| DRAWING | DRAWN |
|-----------------------------|----------------|
| 3 AMENDED AS PER DEV LETTER | VP 2014.06.30 |

CLIENT: Mr B. BUTCHER & Mrs R. BUTCHER
ADDRESS: LAKESIDE PARADE
SUBURB: JORDAN SPRINGS POSTCODE: 2747 COUNCIL: PENRITH

HOUSE DESIGN: HAVANA RENWICK
FACADE DESIGN: CLASSIC
SHEET TITLE: COVER SHEET

JORDAN SPRINGS - ILLOURA - LANDSCAPE CHECKLIST

HOUSE DESIGN: HAVANA RENWICK
 FACADE DESIGN: CLASSIC
 SHEET TITLE: SITE PLAN
 HOUSE CODE: H-HAVCLAS10410
 FACADE CODE: F-HAVCLAS01
 SCALES: 1:200, 1:100
 SHEET No: 3/13

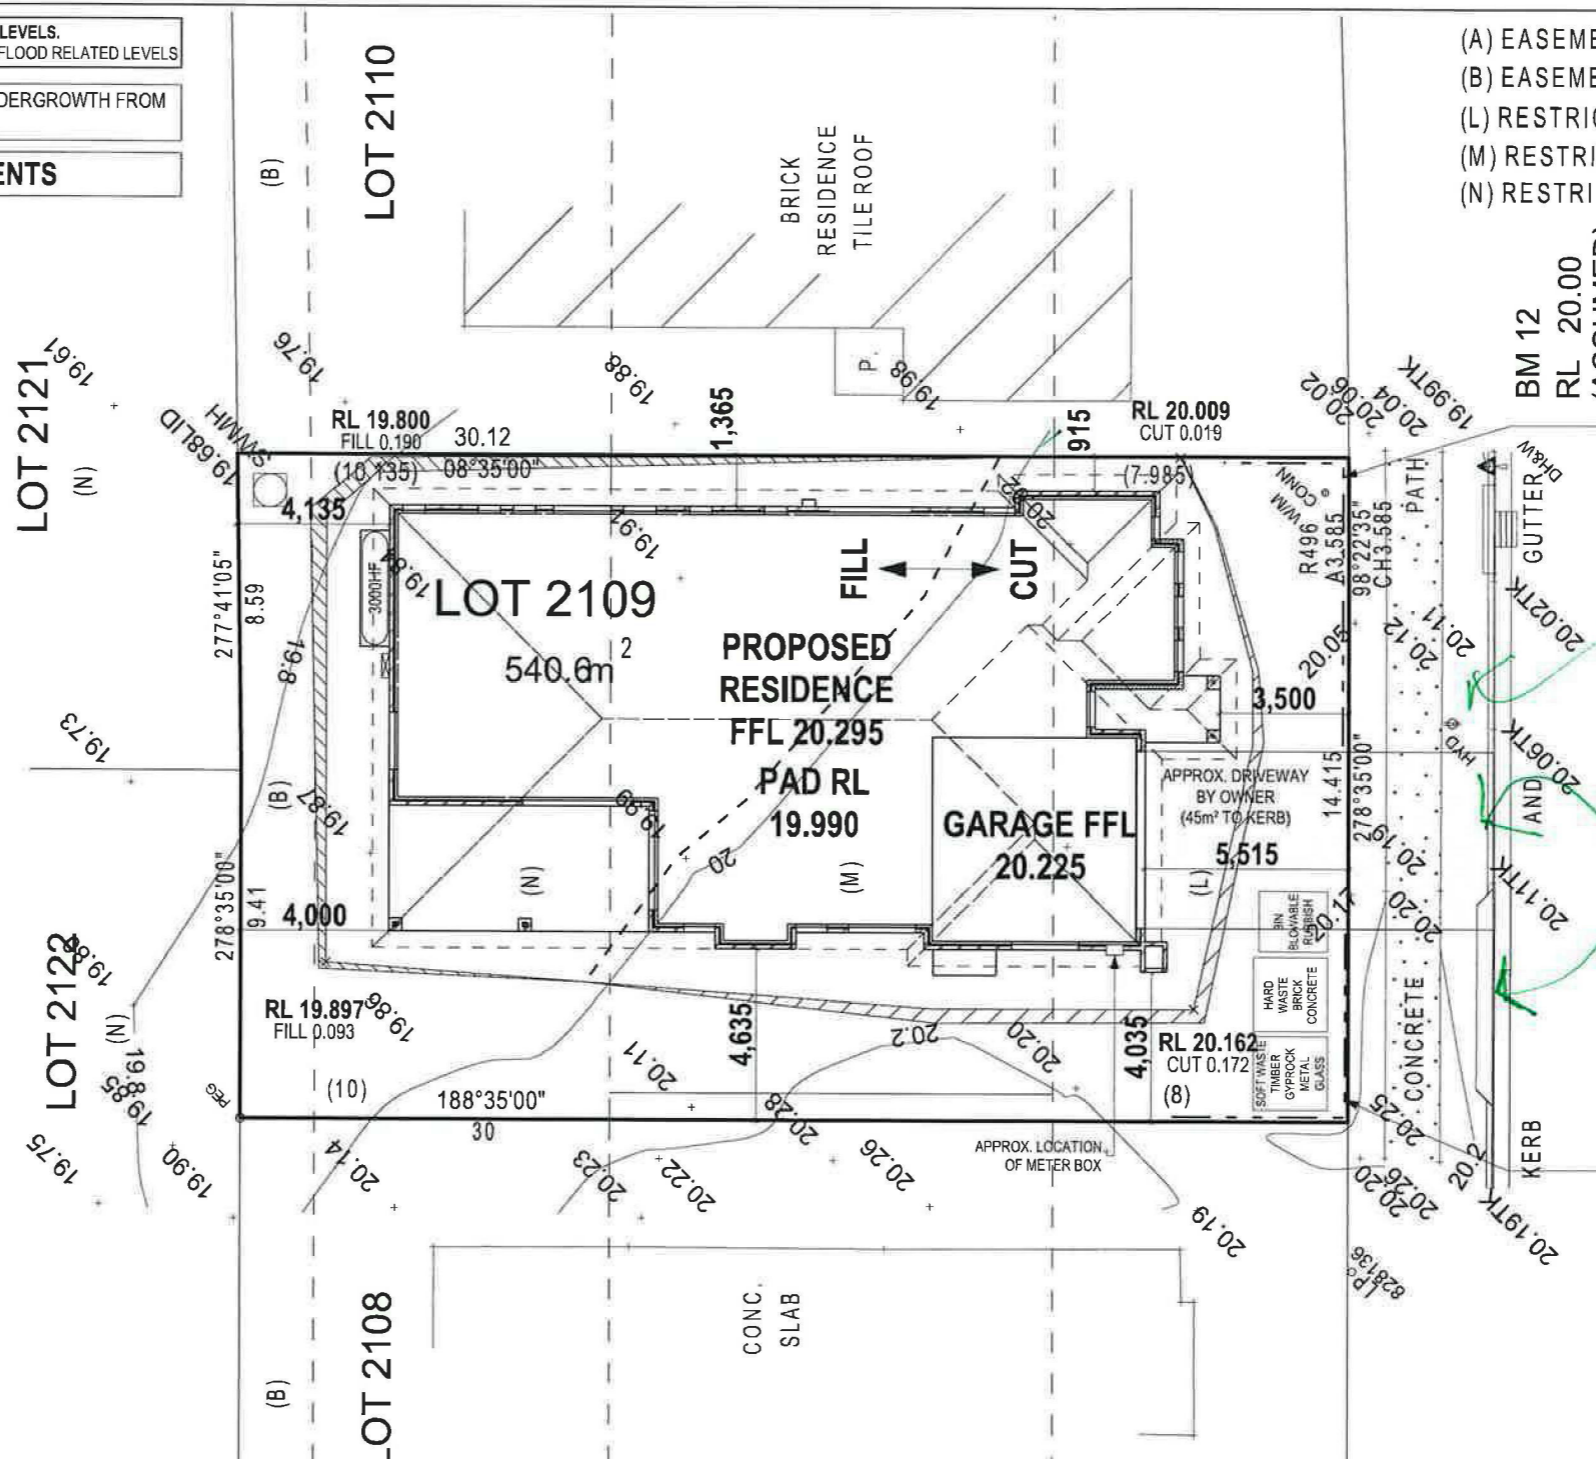
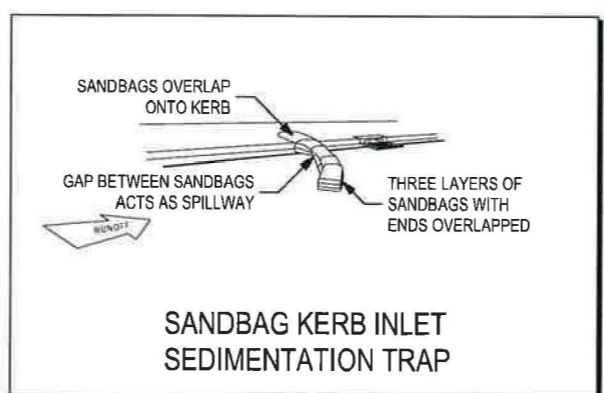
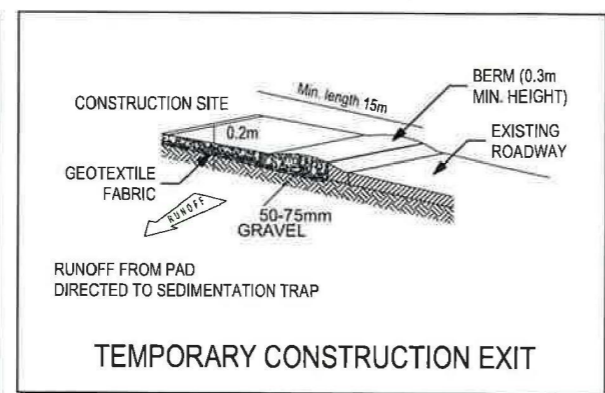
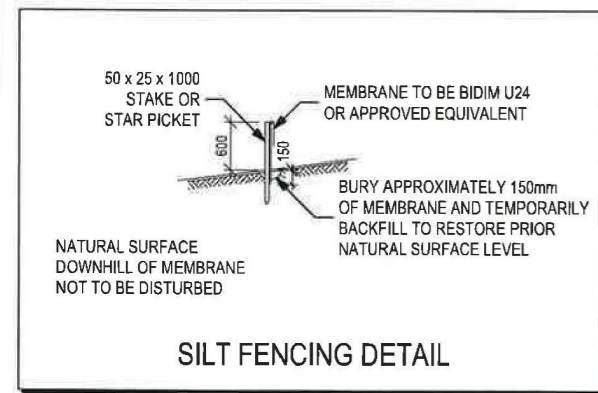
EXISTING STREET TREES IS TO BE LOCATED AND 6 TO BE RELOCATED TO ADJACENT LOT IN FRONT OF LAKESIDE PARADE OWNERS/BUYERS EXPENSE IF REQUIRED

EXISTING LAYBACK IS TO BE RELOCATED AND RECTIFIED AT OWNER/BUILDER EXPENSE SUBJECT TO APPROVAL

Reviewed by L. COVENANT
 Signed: [Signature]

SHEET TITLE:
ELEVATIONS

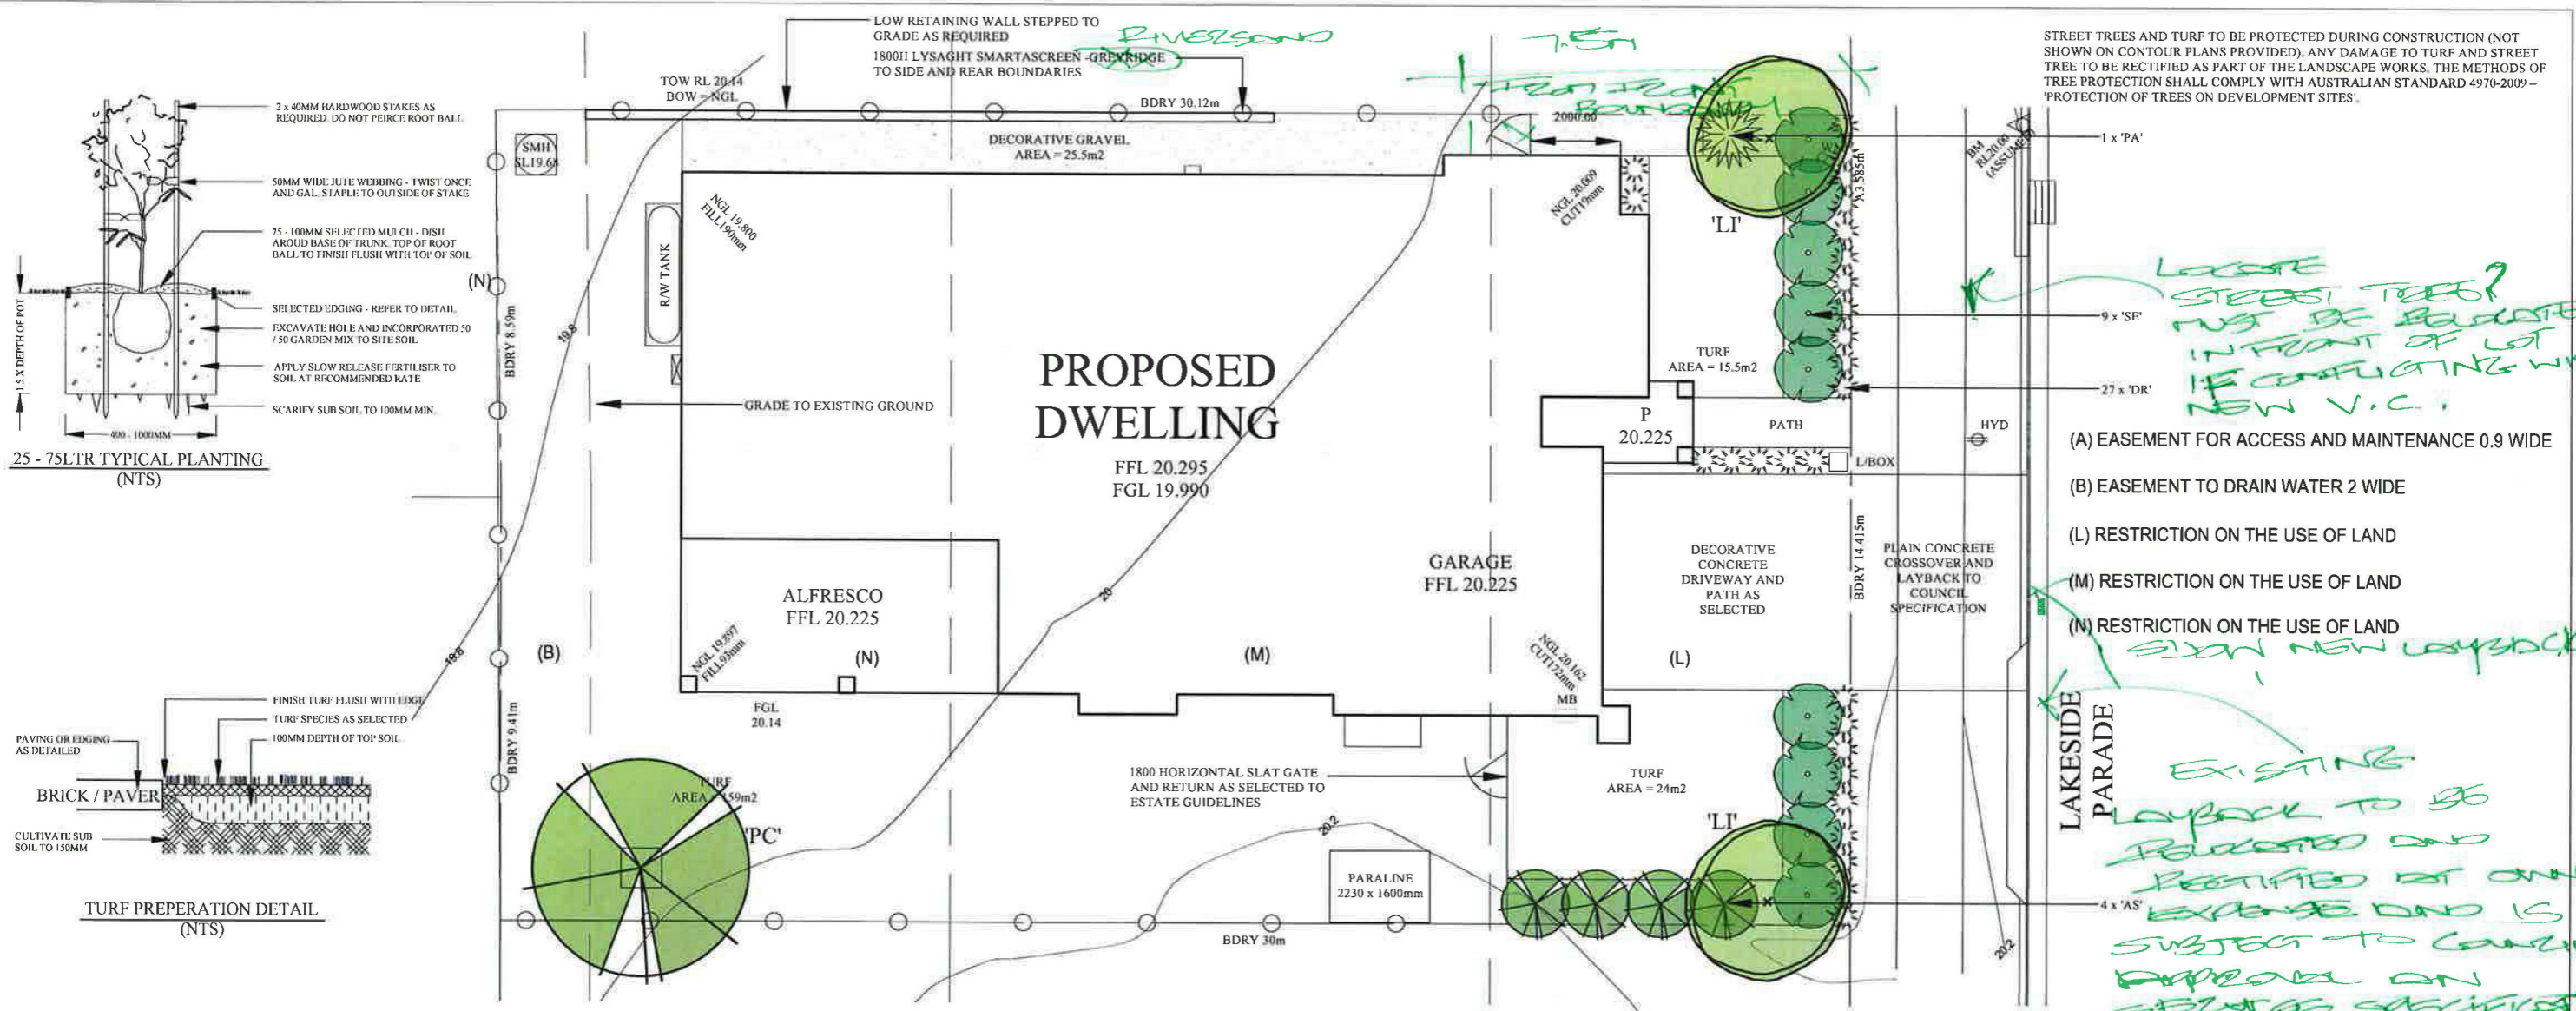
STREET TREES AND TURF TO BE PROTECTED DURING CONSTRUCTION (NOT SHOWN ON CONTOUR PLANS PROVIDED). ANY DAMAGE TO TURF AND STREET TREE TO BE RECTIFIED AS PART OF THE LANDSCAPE WORKS. THE METHODS OF TREE PROTECTION SHALL COMPLY WITH AUSTRALIAN STANDARD 4970-2009 - 'PROTECTION OF TREES ON DEVELOPMENT SITES'.

LOOSE STREET TREES? MUST BE RELOCATED IN FRONT OF LOT IF CONFLICTING WITH NEW V.C.I.

EXISTING PLAYBACK TO BE RELOCATED AND RECTIFIED AT OWNER'S EXPENSE AND IS SUBJECT TO COUNCIL APPROVAL ON SPECIFIC SPECIFICATIONS

REMOVE NOTE

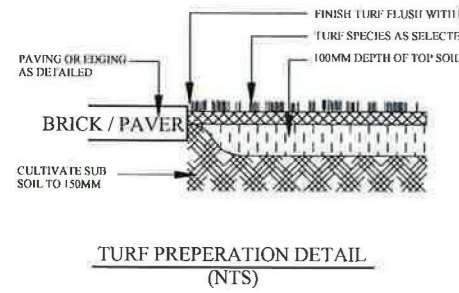
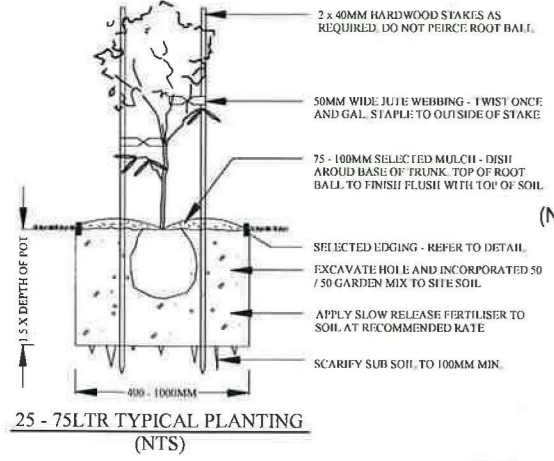
- * 50% OF PLANTING ARE TO BE NATIVE AUSTRALIAN SPECIES, WITH PERCENTAGE NOTED. **YES**
 - * THE EXISTING STREET TREE IS TO BE CLEARLY AND ACCURATELY INDICATED ON THE PLAN. THE LANDSCAPE PLAN MUST NOTE THAT THE STREET TREE AND TURF AREAS IN FRONT OF THE HOUSE ARE TO BE PROTECTED DURING CONSTRUCTION, WITH ALL DAMAGE TO BE RECTIFIED AS PART OF THE LANDSCAPE WORKS. **NO**
